UNITED STATES OF AMERICA  
NUCLEAR REGULATORY COMMISSION

In the Matter of )  
PACIFIC GAS AND ELECTRIC COMPANY ) Docket Nos. 50-275 O.L.  
(Diablo Canyon Nuclear Power Plant ) 50-323 O.L.  
Unit Nos. 1 and 2 )

TESTIMONY OF PAO-TSIN KUO

Attachment 1

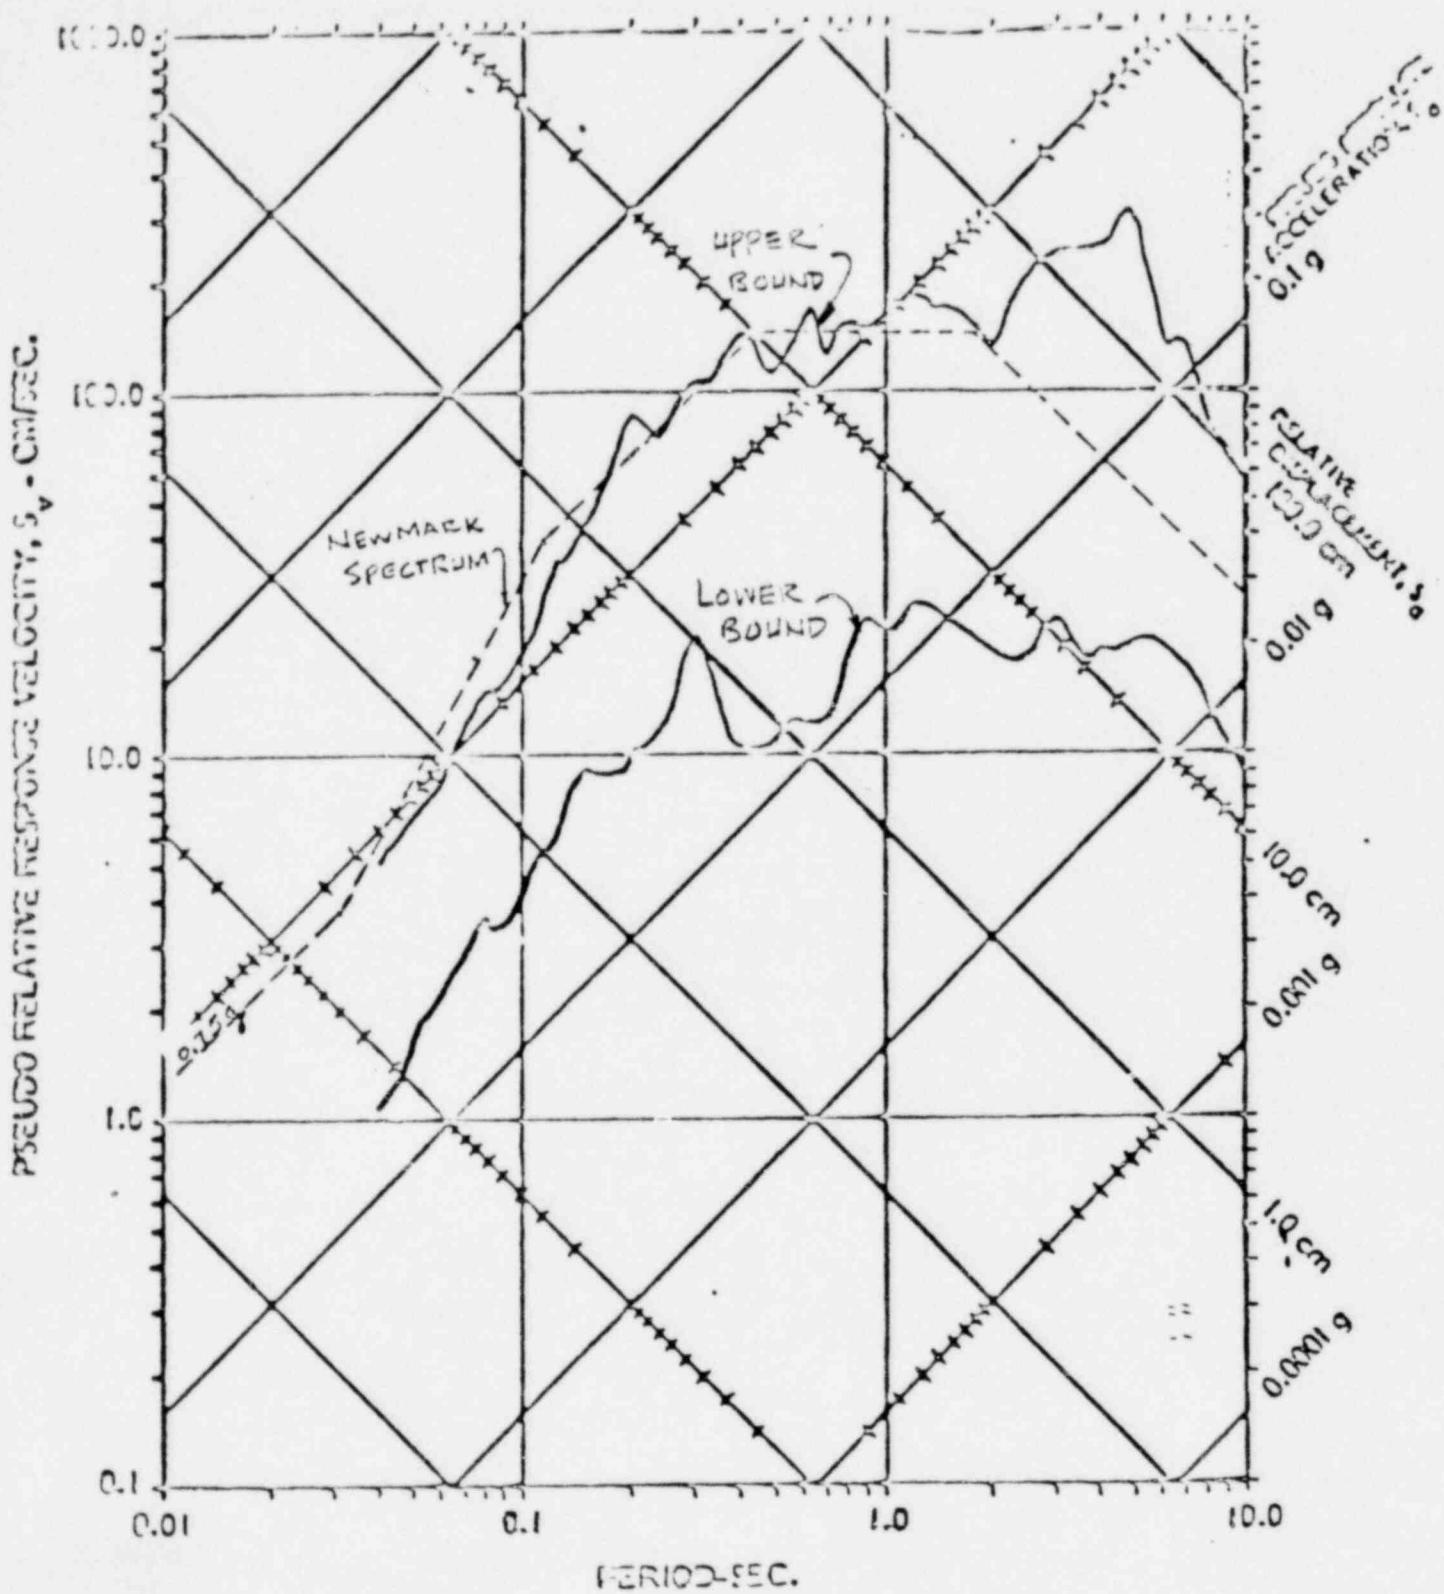
A. Attachment 1 is a plot of an envelope of upper and lower bounds of all horizontal response spectra for 5% damping generated from the IV-79 motions recorded within 11 Kilometers of the fault. Plotted in the same graph is also a Newmark horizontal design spectrum for 5% damping used for the Diablo Canyon seismic reanalysis.

It can be seen that for periods in the range of interest (i.e., lower than 0.5 seconds), the Newmark design spectrum is for the most part above the upper bound envelope of the IV-79 data. For a few places where the Newmark design spectrum falls below the upper bound envelope, the differences are minor. Should a smoothed, average response spectrum be generated from the IV-79 data for a mean zero period acceleration scaled up to 0.75g as suggested on p. 22 of the ALAB-598 decision, in my opinion it would be bounded by the Newmark design spectrum for Diablo Canyon over the frequency range of interest (i.e., above 2 Hz for DCNPP). This is because the amplification factors exhibited in the

IV-79 data do not appear to be greater than those used in the Newmark design spectrum. Therefore, the few small exceedances shown in Attachment 1 will not be heavily weighted if a statistical averaging process were applied to the entire IV-79 data set.

COMPARISON OF NEWMACK VERTICAL SPECTRUM AND  
VERTICAL SPECTRA DEVELOPED FROM THE IV-79 DATA  
ALL FOR 5% OF CRITICAL DAMPING

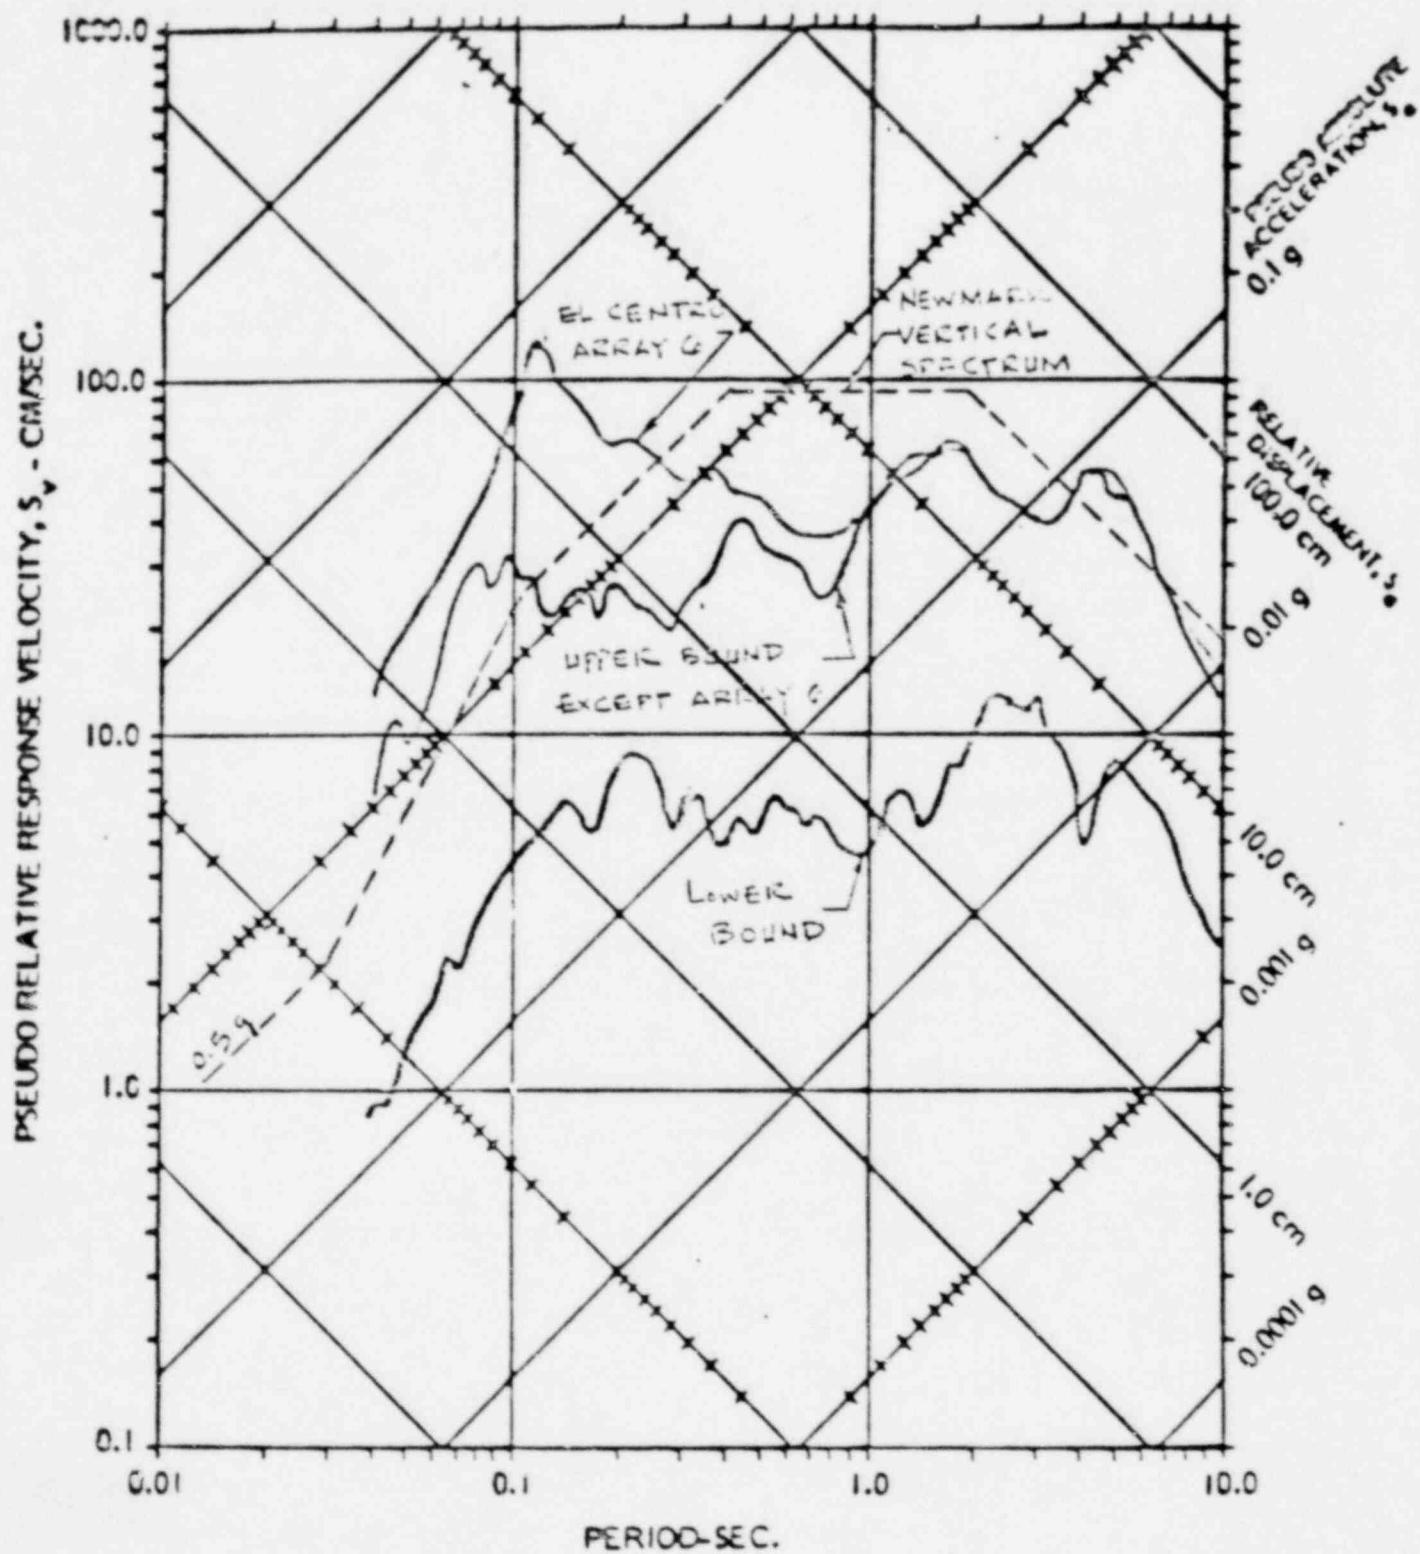
Attachment 2 is a plot of the vertical response spectrum at El Centro Array 6 Station and the upper and lower bounds of all the remaining vertical response spectra for 5% damping generated from the IV-79 motions recorded within 11 kilometers of the fault. Plotted in the same graph is also a Newmark vertical design spectrum for 5% damping used for Diablo Canyon seismic reanalysis.

The same type of trends explained above for the horizontal response spectra can also be said for the vertical response spectra. Although it is seen that the vertical spectrum at the El Centro Array 6 station is considerably above the Newmark vertical spectrum, because of the peculiar geological environment at that station as explained in Dr. Rothman's testimony, this spectrum is considered nonrepresentative of the IV-79 data in general. More discussions on the vertical response spectra are given in my response to the Board's Question 4.
